## **Porthkerry Road, Rhoose Technical Note – Assessment of Revised Access**

This technical note, which has been produced to provide further supporting evidence for the proposed housing application at Porthkerry Road Rhoose (Application Number 2014/00550/OUT), provides details of geometrical changes that have been made to the design of the scheme's proposed main access on Porthkerry Road. The revisions to the access represent an update from the original drawing (CIV15342-C-SA-95-SK01 A08), which was included as Appendix F of the schemes supporting Transport Assessment (TA) dated May 2014 and is also included as Appendix A of this technical note. Amendments to the drawing have been made to address comments raised by Vale of Glamorgan (VoG) highways regarding the original access proposals, which are also discussed within this note.

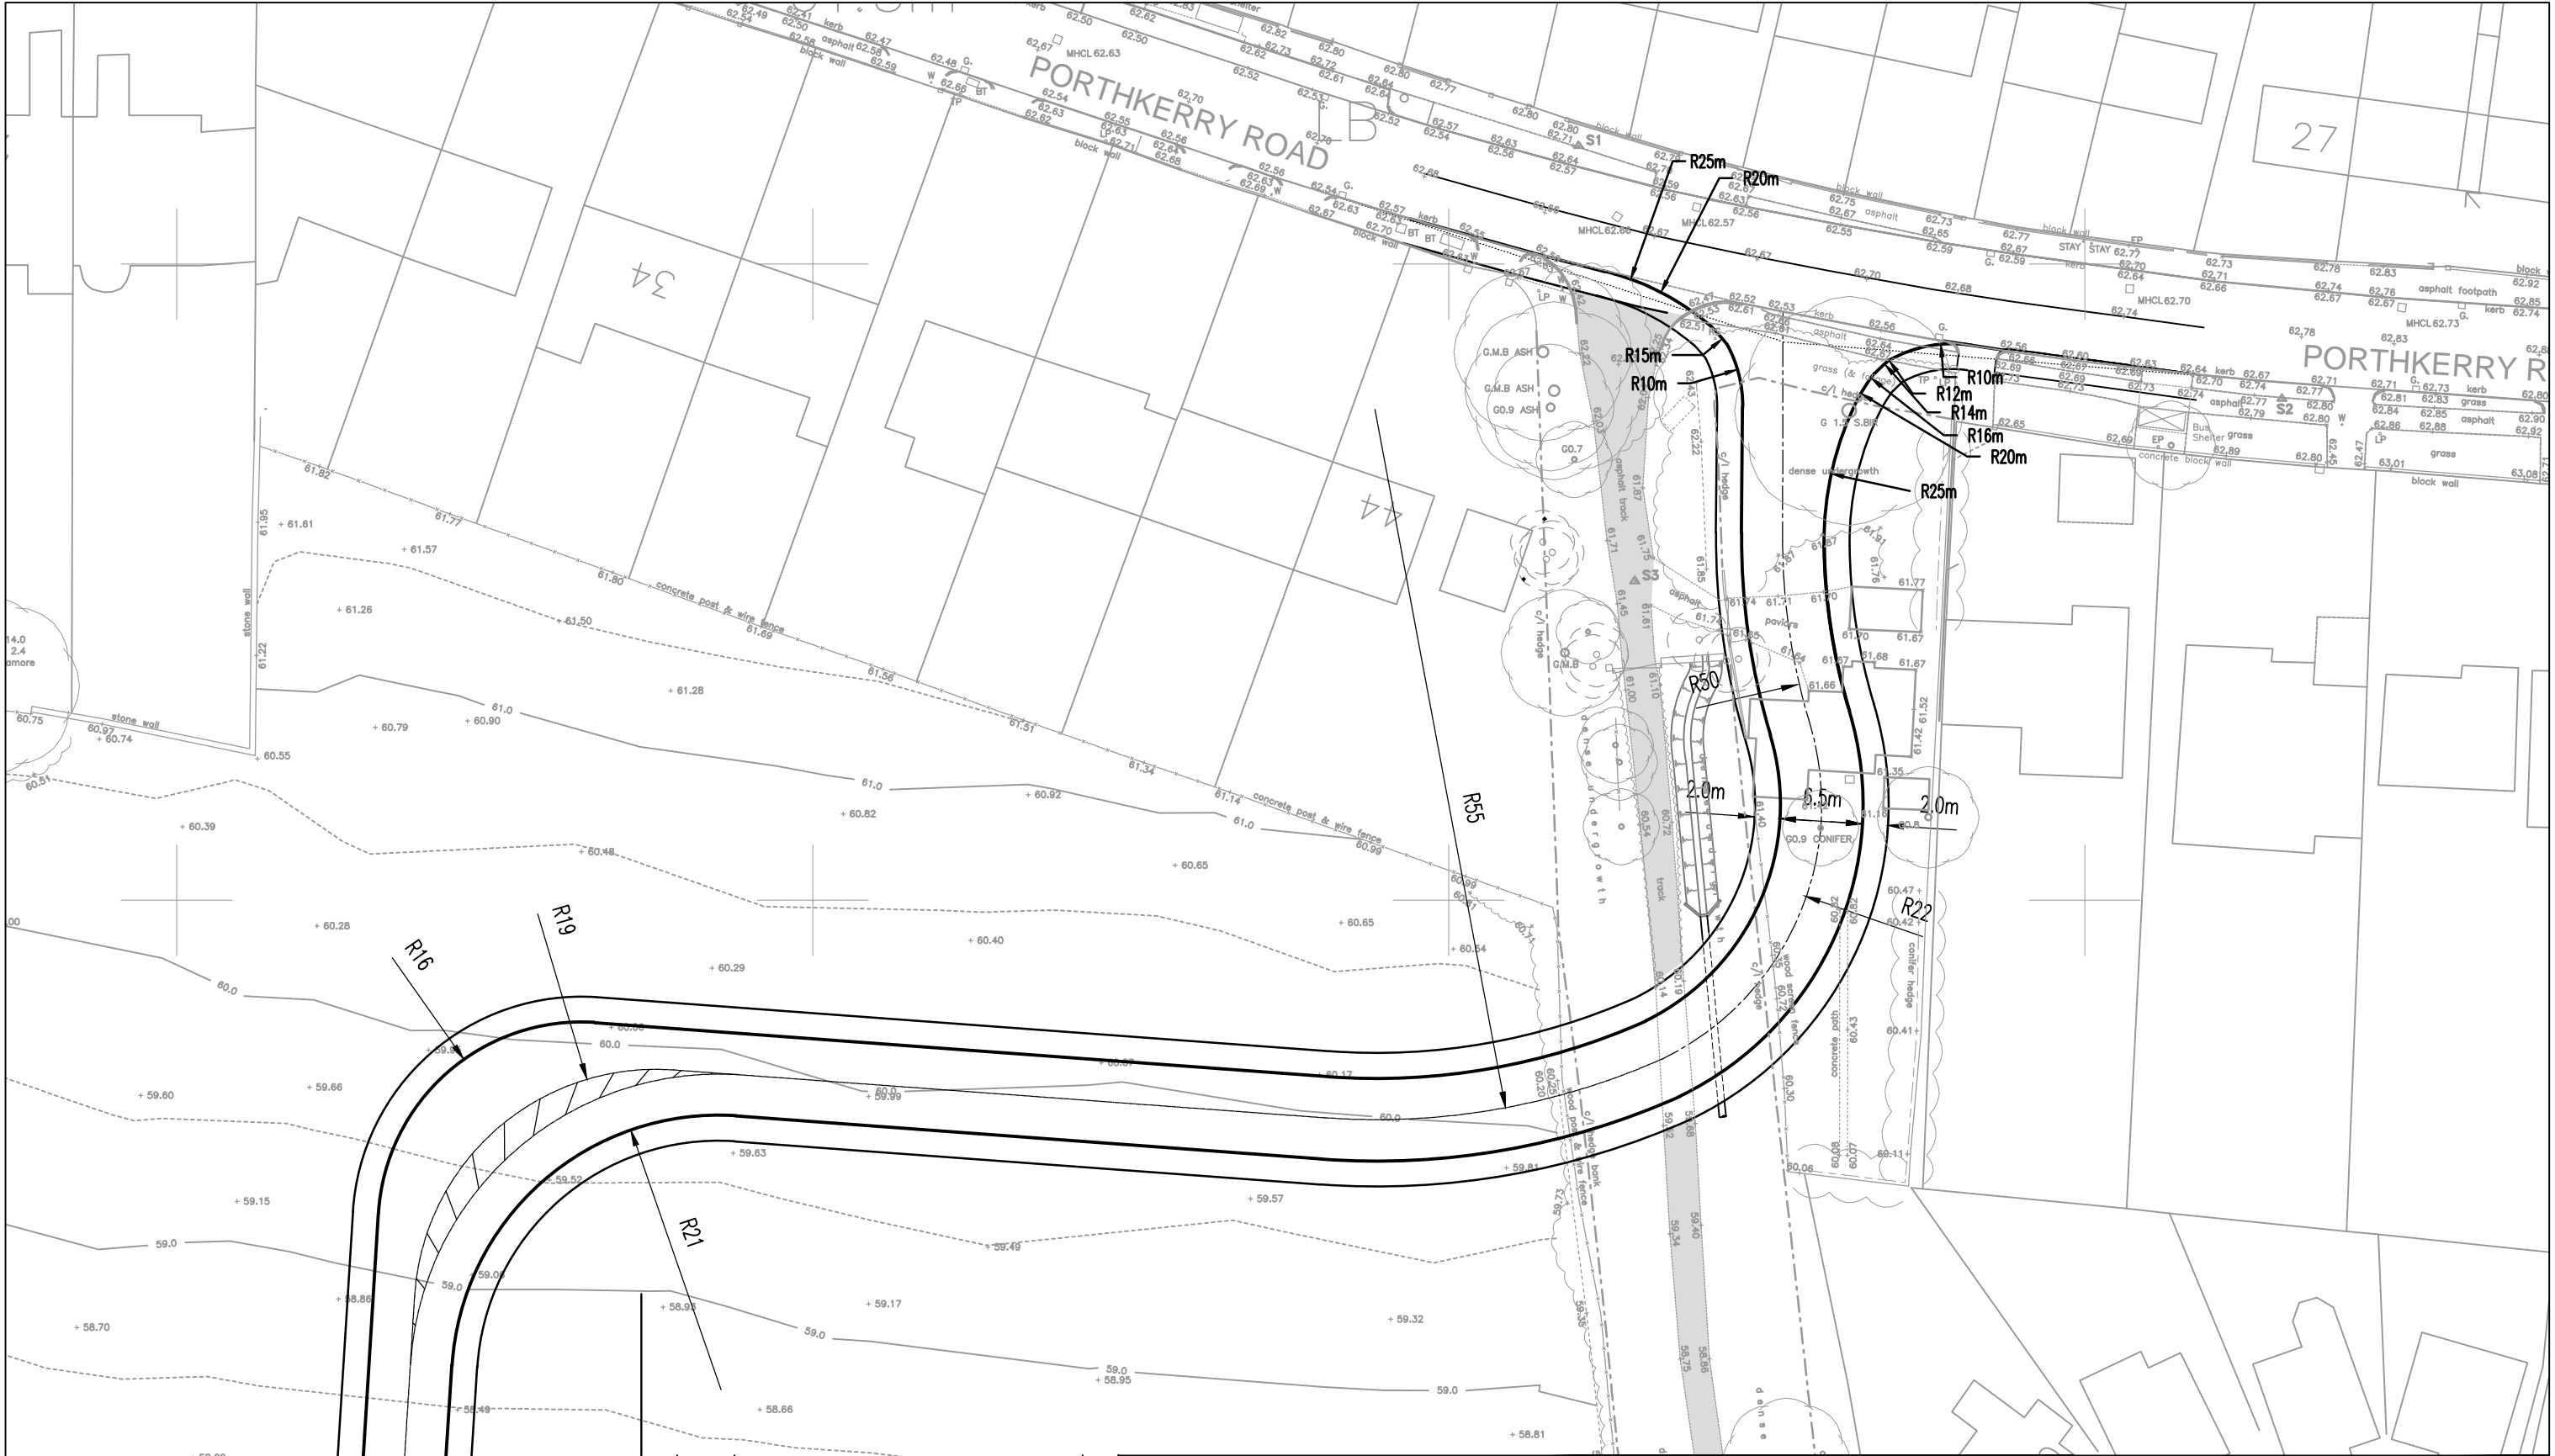
VoG have now stated that the development access would need to accommodate bus movements within the site. They have also requested that swept path movements should be provided for an 11m long bus that show that this type of vehicle can turn into and out of the site without conflict. In addition, VoG have also expressed concerns regarding the right angle bend within the western portion of the site and the ability of buses to negotiate this corner without conflicting with vehicles travelling in the opposite direction. Previous swept path analysis carried out of the access has shown that whilst buses of this size can access the site within the proposed road space there is a requirement in some instances for the vehicle to marginally overrun the centreline. This design was proposed on the basis that the only buses expected to access the site would be school buses, which will arrive and depart on a weekly basis.

A revised access design has therefore been provided as Appendix B (Drawing CIV15342-C-SA-95-SK15 1<sup>st</sup> Issue). This design includes amendments to the geometry of the access to address VoG's comments. These changes include adjustments to the radii at the junction mouth and the widening of the road / increase of turning radii on the western bend within the site. The width of the access road has also been reduced from 6.8m to 6.5m so that it is consistent with the agreed width of the internal roads.

### **C. Autotrack Analysis of Revised Access Proposals**

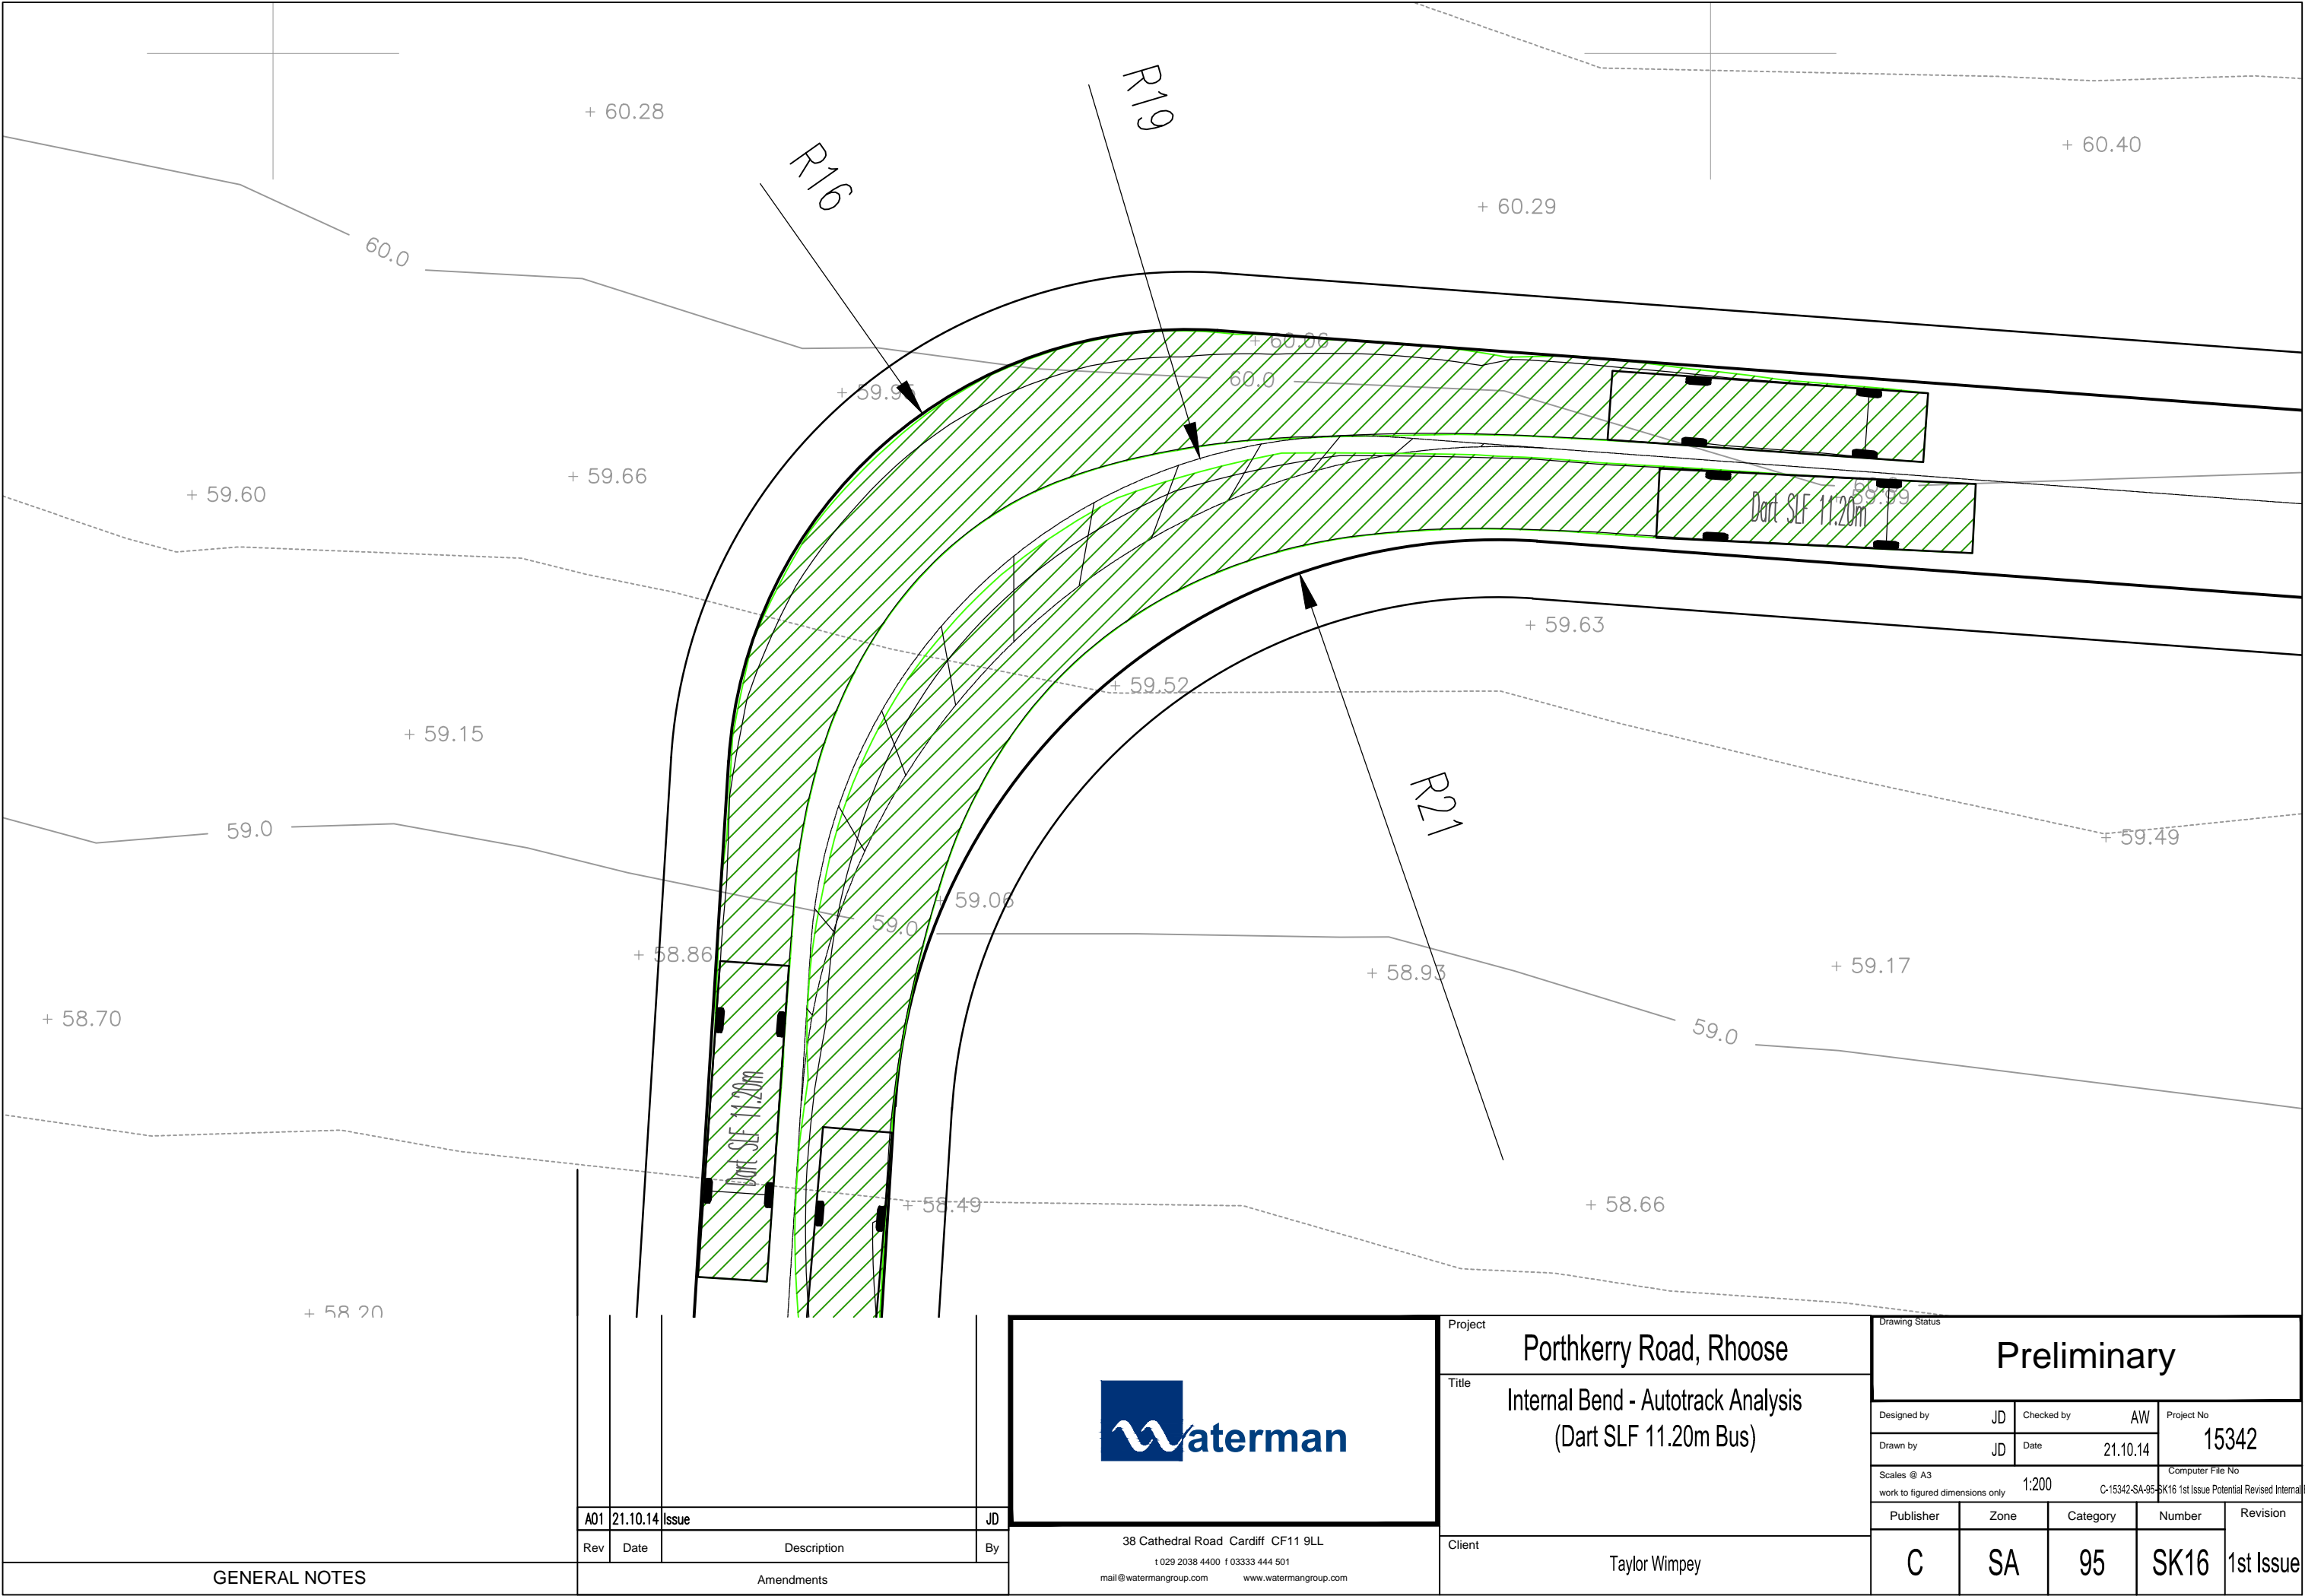
Drawings showing the swept path movements of buses (Dart SLF 11.20m) entering and exiting the site access (Drawing CIV15342-C-SA-95-SK12 1<sup>st</sup> Issue), and negotiating the revised internal bend within the western portion of the site (Drawing CIV15342-C-SA-95-SK16 1<sup>st</sup> Issue) have been included as Appendix C. These drawings show that a bus (approximately 11m in length) can negotiate the access and internal bend without conflicting with vehicles travelling in the opposite direction.
